# SERVICE BULLETIN

**Subject: GS-X Setting Table Cable Assembly**

**Bulletin No. SB10-11**

*Figure 1*

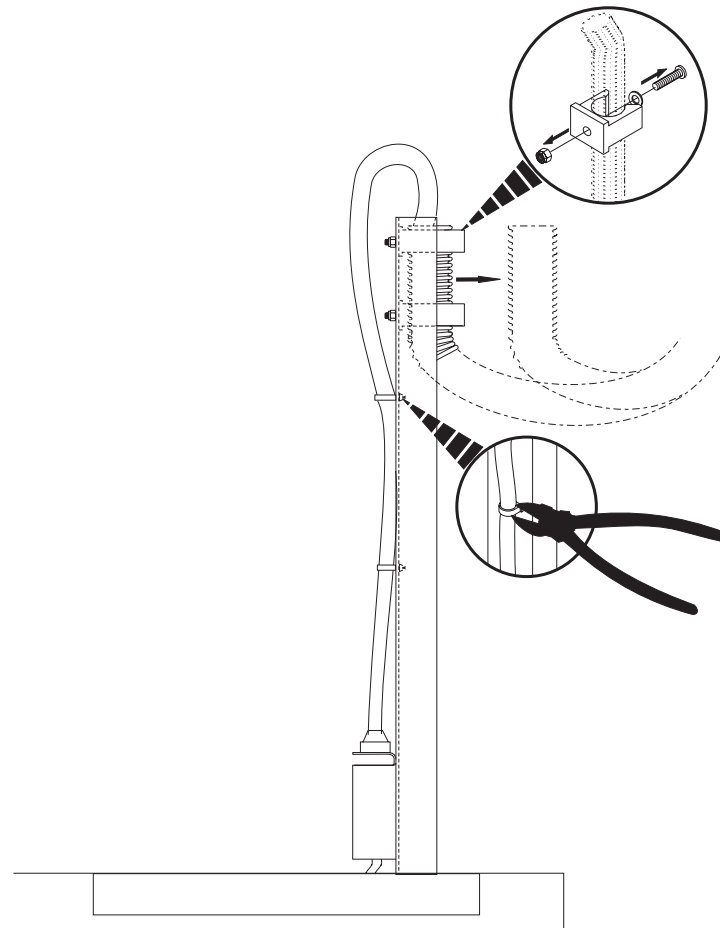
1. At the table cable guide tower, cut and remove the white plastic cable tie located at the third hole from the top. Remove the cable from the 2 cable retaining clips and remove the top clip. Refer to *Figure 1*.

*Figure 2*

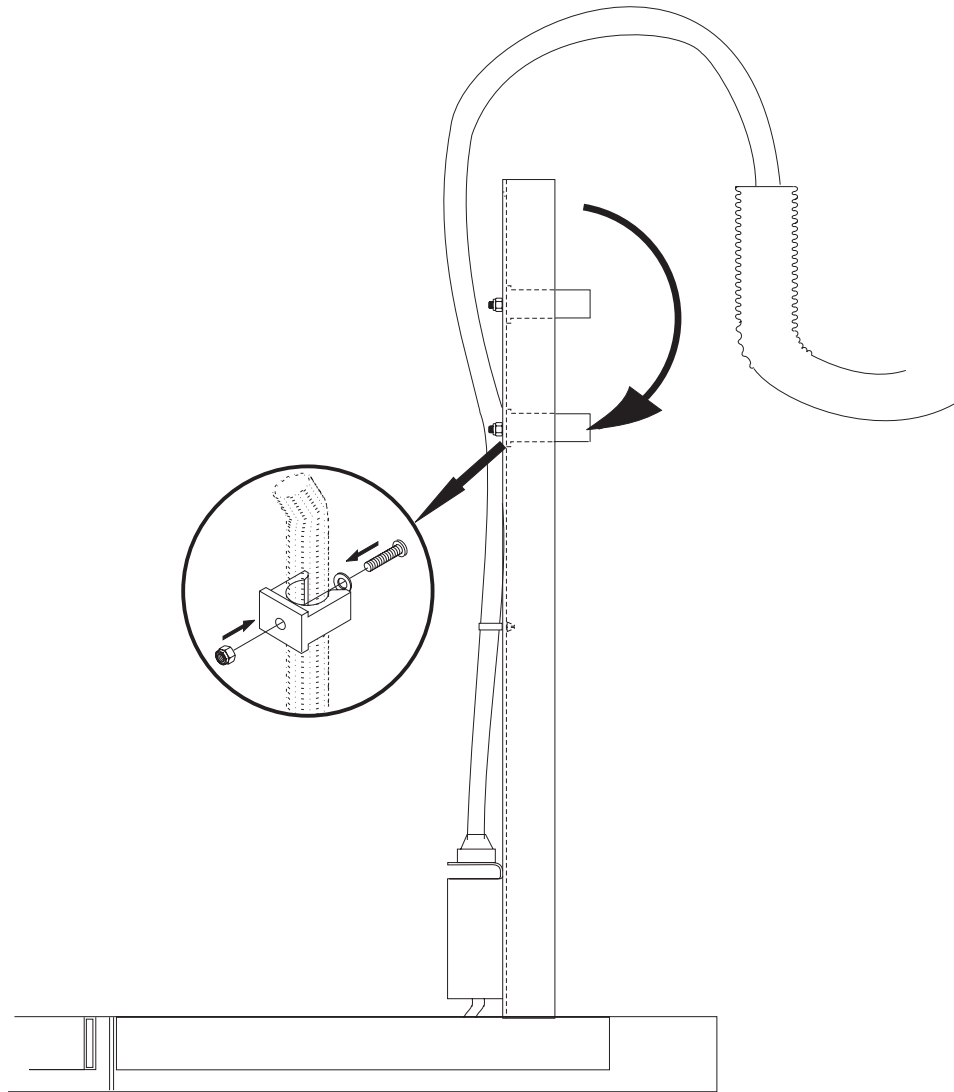
2. Install the retaining clip removed in step 1, in the hole previously occupied by the plastic cable tie. Refer to *Figure 2*

*Figure 3*

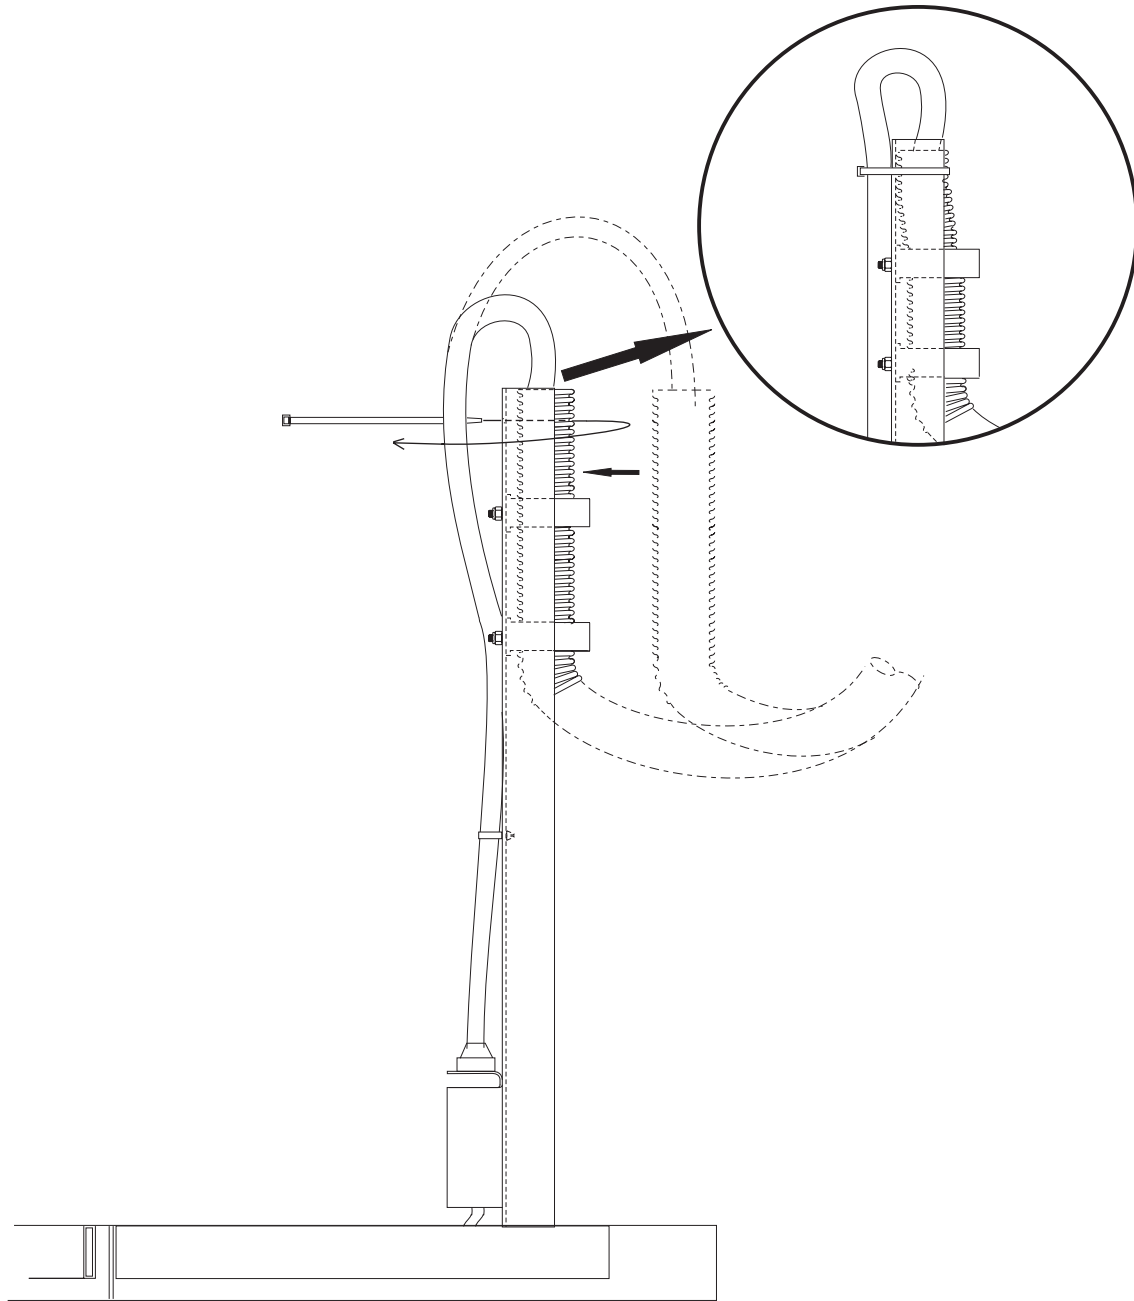
3. Reinstall the cable and flex tubing into the retaining clips and using the top hole and a cable tie, secure the table cable and protection conduit tight to the guide tower. Refer to *Figure 3*.

*Figure 4*

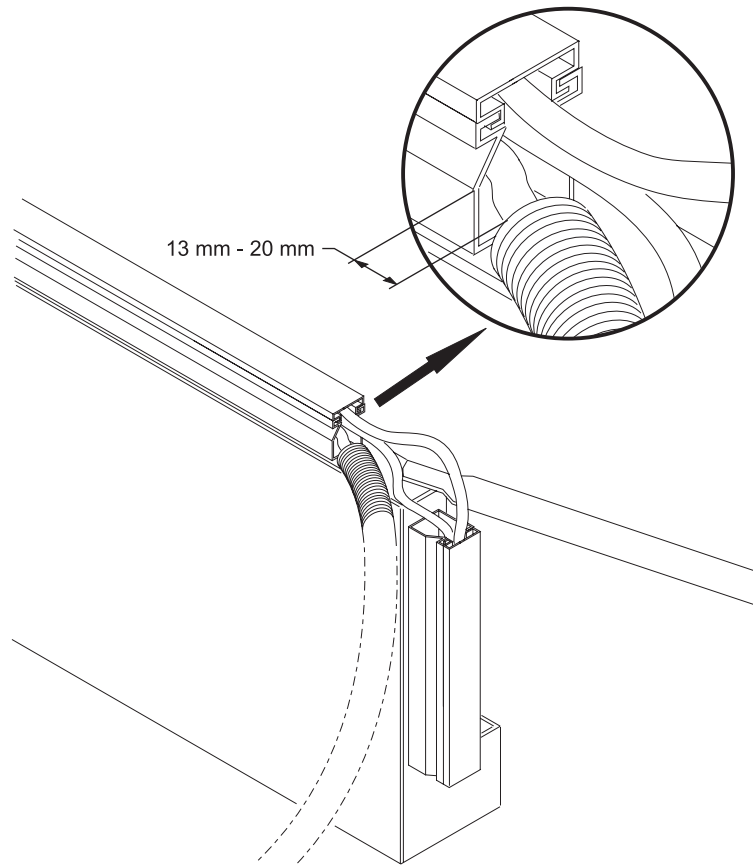
4. Verify the cable is pulled out of the cable raceway at the top of the pinsetter frame so that the cable does not bent sharply or is not pulled from the lower retaining clip when the table moves to the new pin setting height. Refer to *Figure 4*.
